STATE OF MAINE
DEPARTMENT OF TRANSPORTATION
16 STATE HOUSE STATION
AUGUSTA, MAINE 04333-0016

February 28, 2023
Subject: Frank J. Wood Bridge Replacement
State WIN: 022603.00
Location: **Brunswick & Topsham**
Amendment No. 2

STATE OF MAINE			
DEPARTMENT OF TRANSPORTATION			
STP-2260(300)			
WIN 22603.00			
BRIDGE NO. 2016			
BRIDGE PLANS			
DATE			
BY			
10/22			
SIGNATURE			
P.E. NUMBER			
DATE			
2/23			
2/23			
FIELD CHANGES			
ESTIMATED QUANTITIES			
SHEET NUMBER			
2B			
OF 163

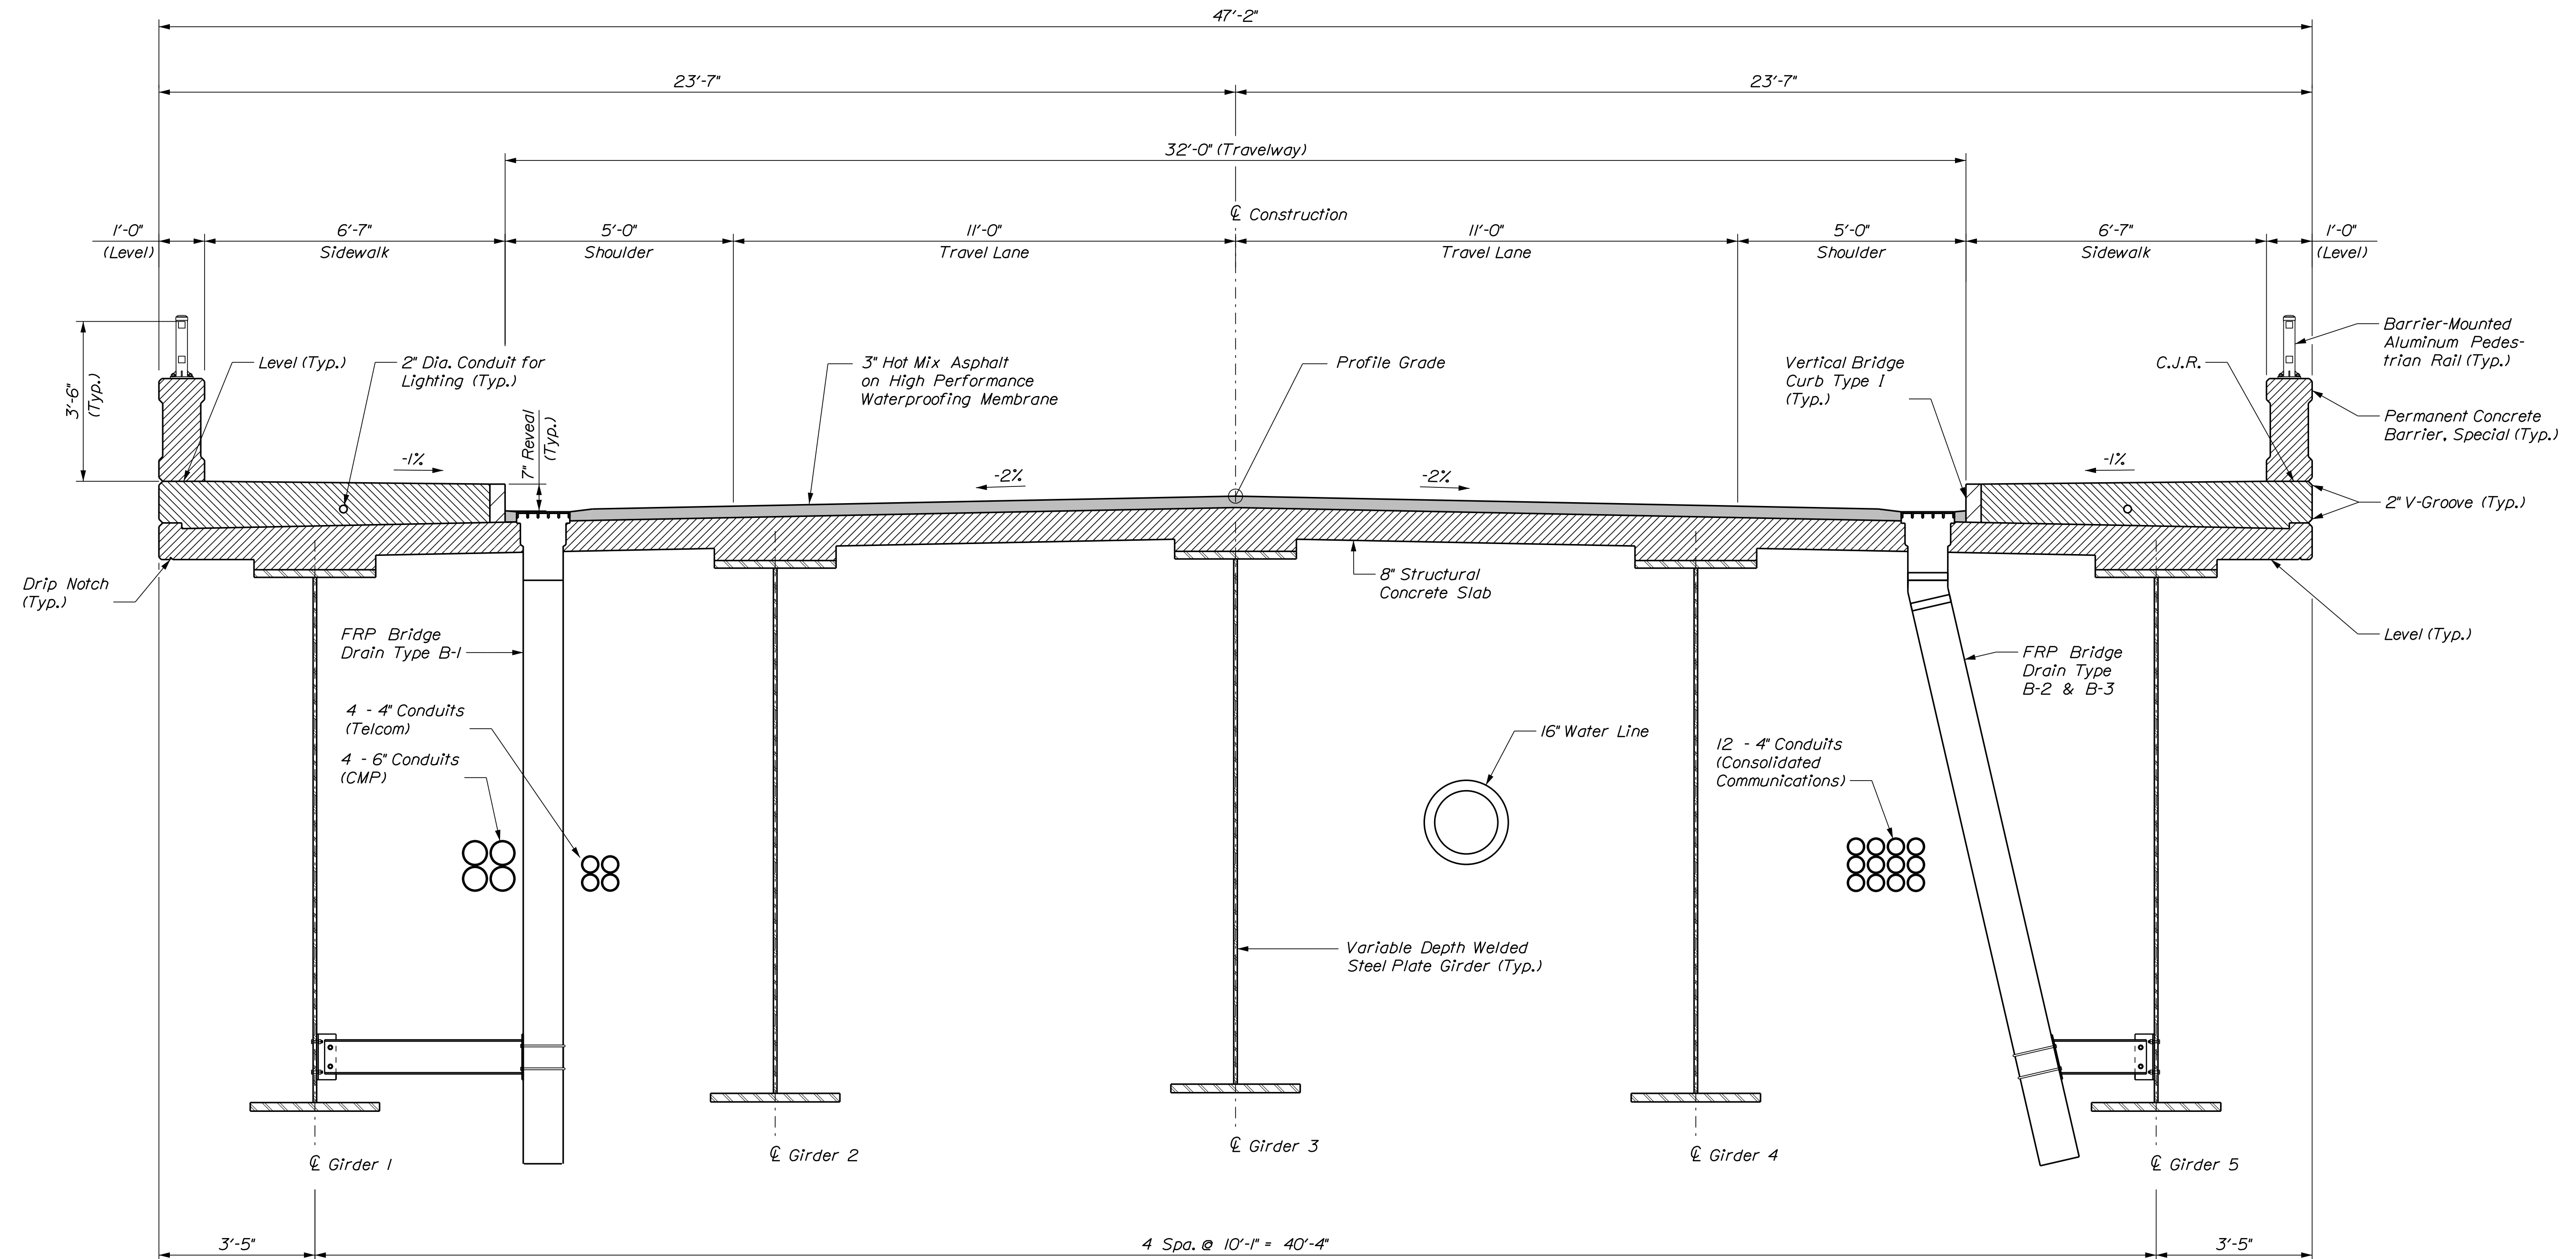
REMOVE sheet 2A, ESTIMATED QUANTITIES, 1 sheet dated 2/23 and **REPLACE** with attached sheet 2B, ESTIMATED QUANTITIES, 1 sheet dated 2/23.

Question: Does the weight listed for item 202.19 Removing Existing Bridge on sheet 2 of 163 Estimated Quantities include the Rosphalt Overlay?

Question: What is the department's estimated quantity of steel that will be removed as part of the existing bridge demolition?

Response: The weight listed for Item 202.19 is estimated and only includes steel.

Response: The weight listed for Item 202.19 on Sheet 2 of 163 Estimated Quantities is an approximate quantity of steel.

TRANSVERSE SECTION

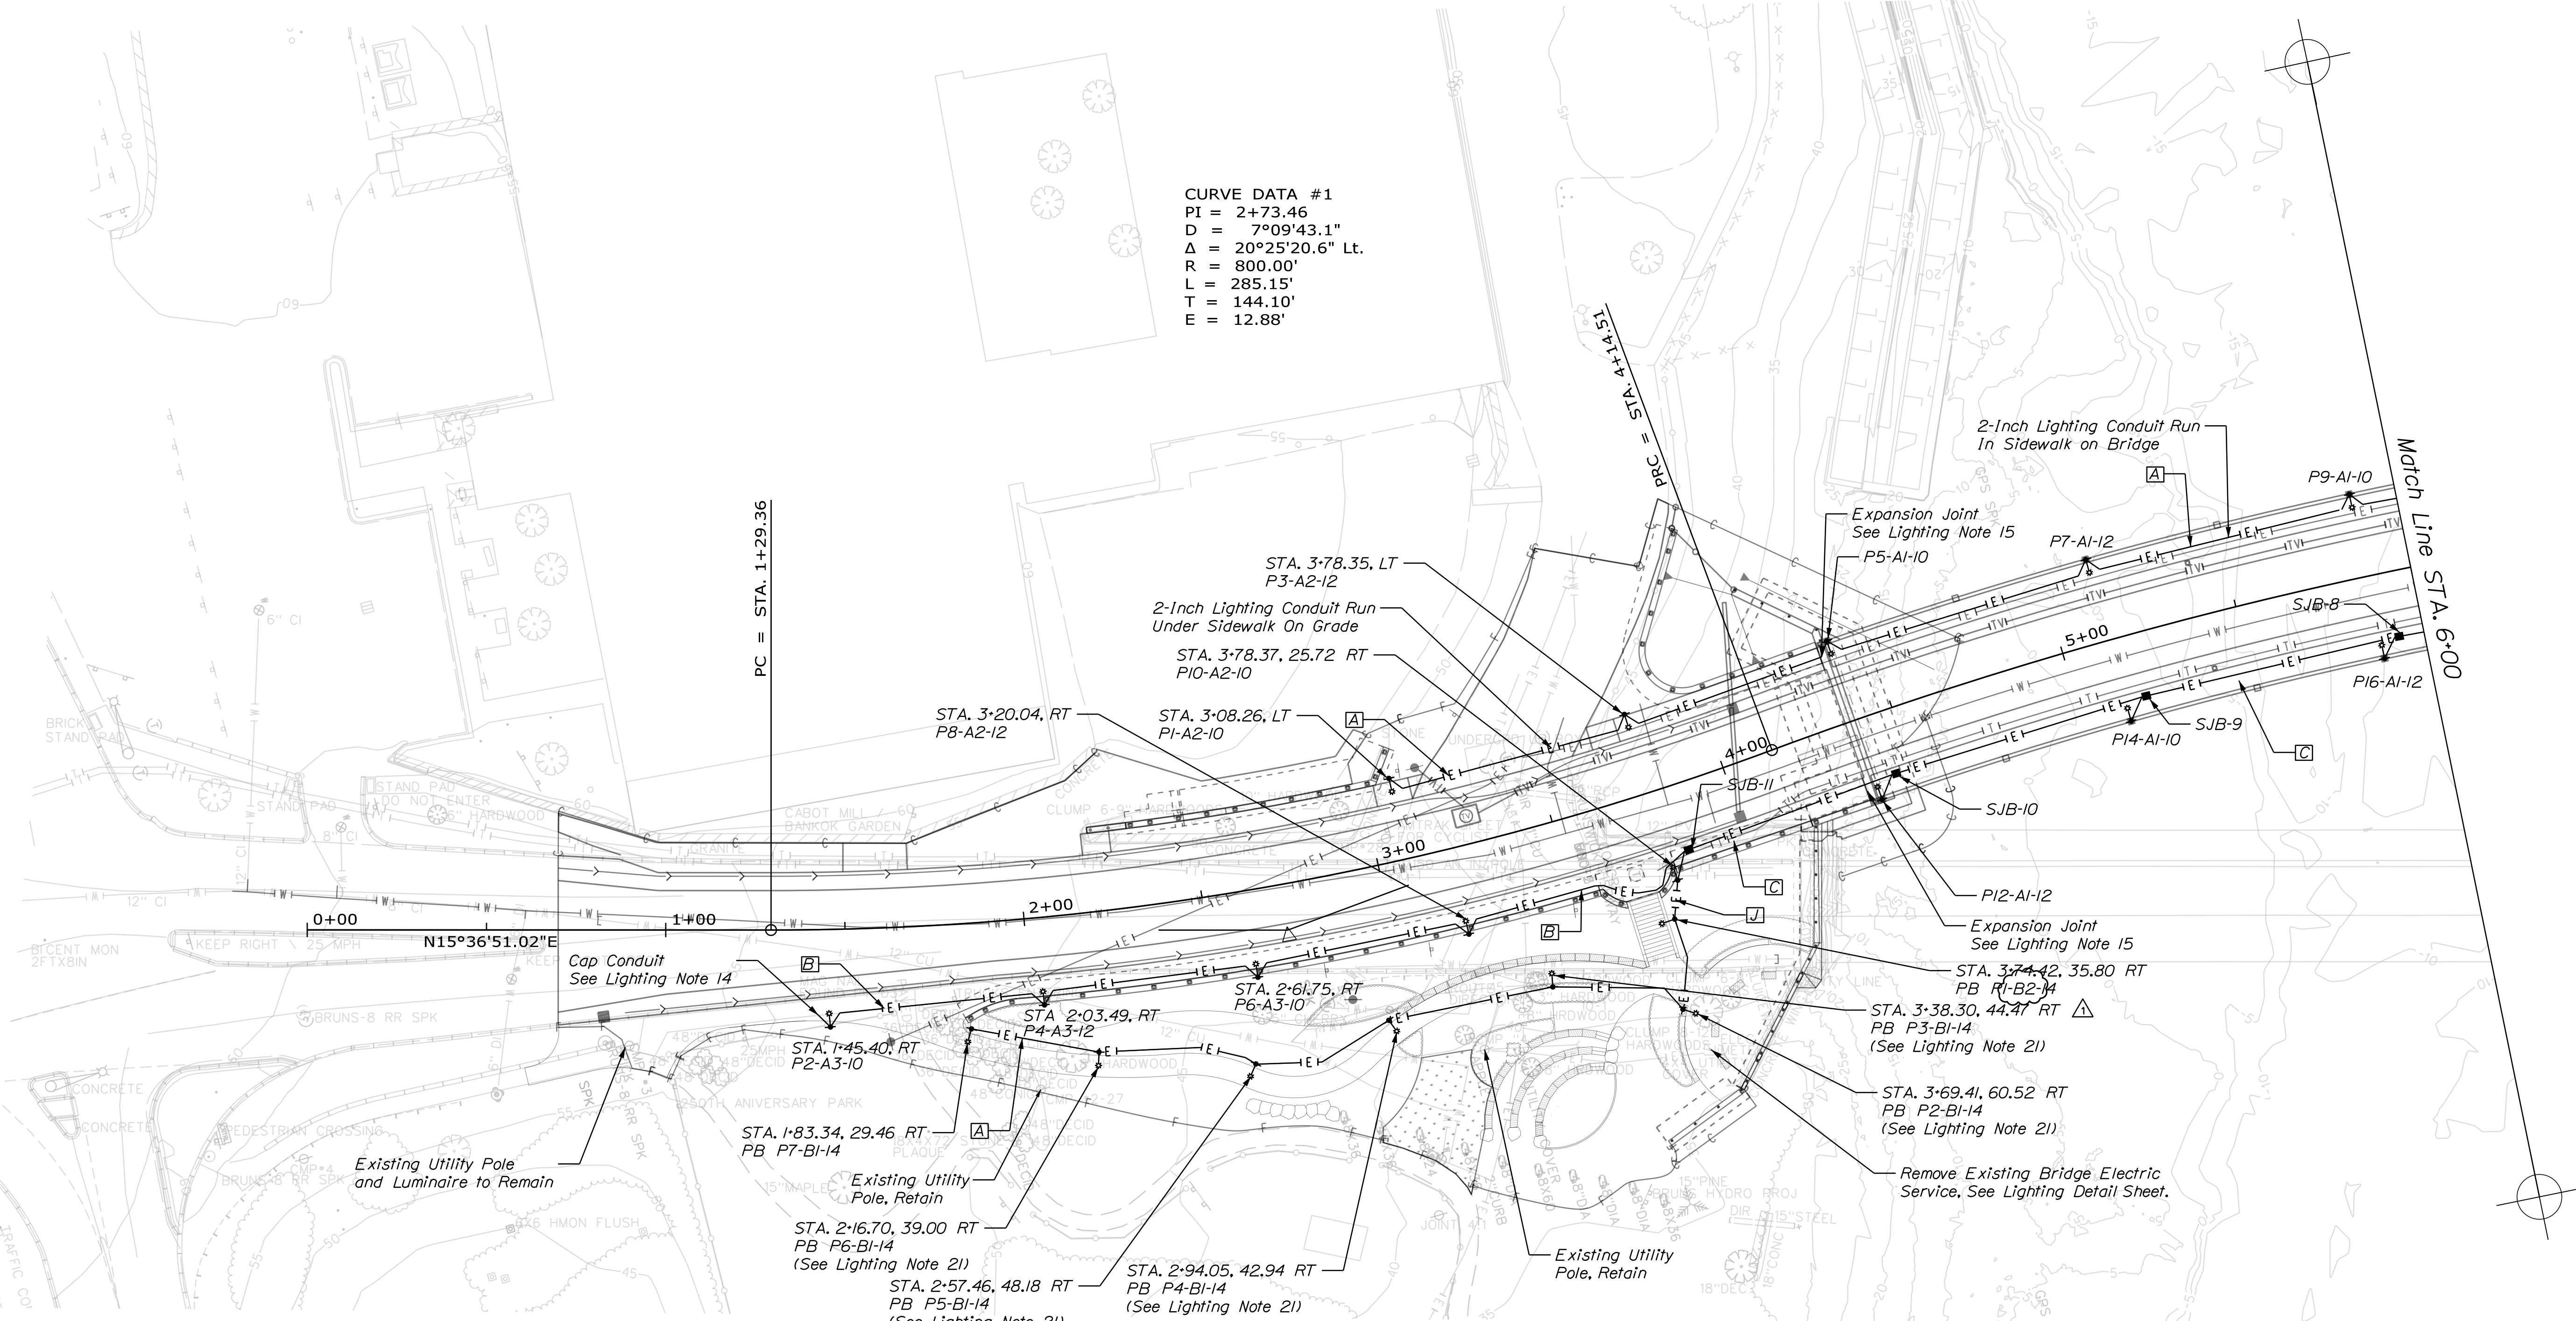
REMOVE sheet 130, TRANSVERSE SECTION, 1 sheet dated 4/20 and **REPLACE** with attached Sheet 130A, TRANSVERSE SECTION, 1 sheet dated 2/23.

Question: Note #8 on sheet 130 states the permanent concrete barrier reinforcing steel is to be stainless steel. Can Low-carbon chromium bars be substituted.

Response: See above changes to the bid documents.

7. Mortar for bedding and for joints in the granite curb shall contain an approved non-shrink additive.
8. Permanent Concrete Barrier reinforcing steel shall be Low-Carbon Chromium

Filename: ...\\106273_43\\157B_Lighting_01.DGN

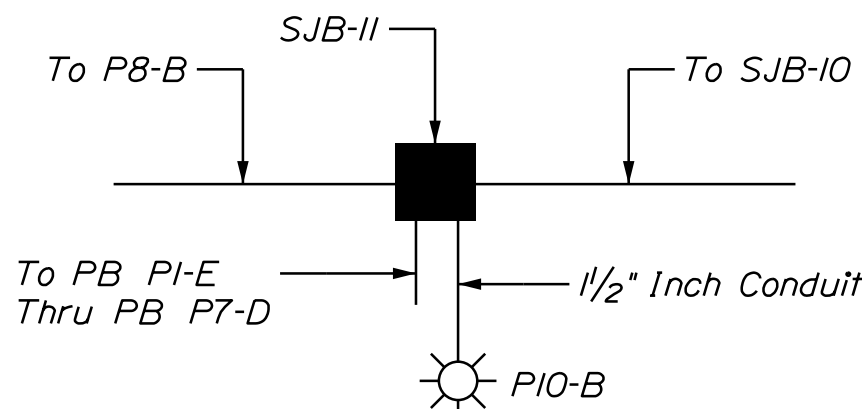
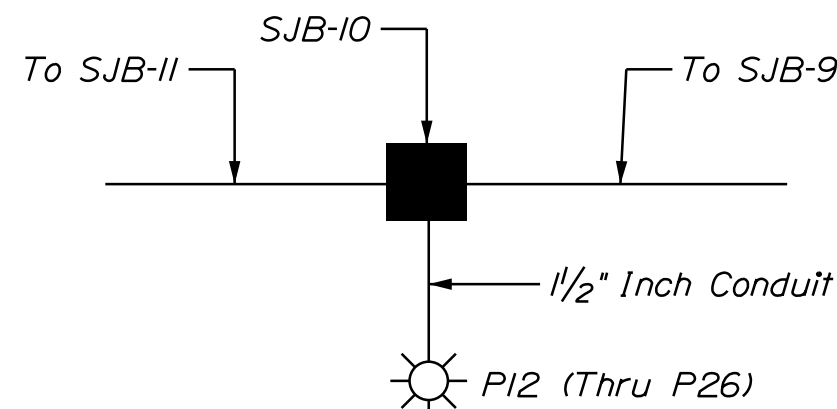
REMOVE sheet 157A, LIGHTING PLAN, 1 sheet dated 2/23 and **REPLACE** with attached Sheet 157B, LIGHTING PLAN, 1 sheet dated 2/23.

Question: Could the Lighting Plan Drawings # 157, 158, and 159 be re-issued indicating only the lighting conduits and Circuits. Also indicating which conduits are to be concrete encased?

Response: See above changes to the bid documents.
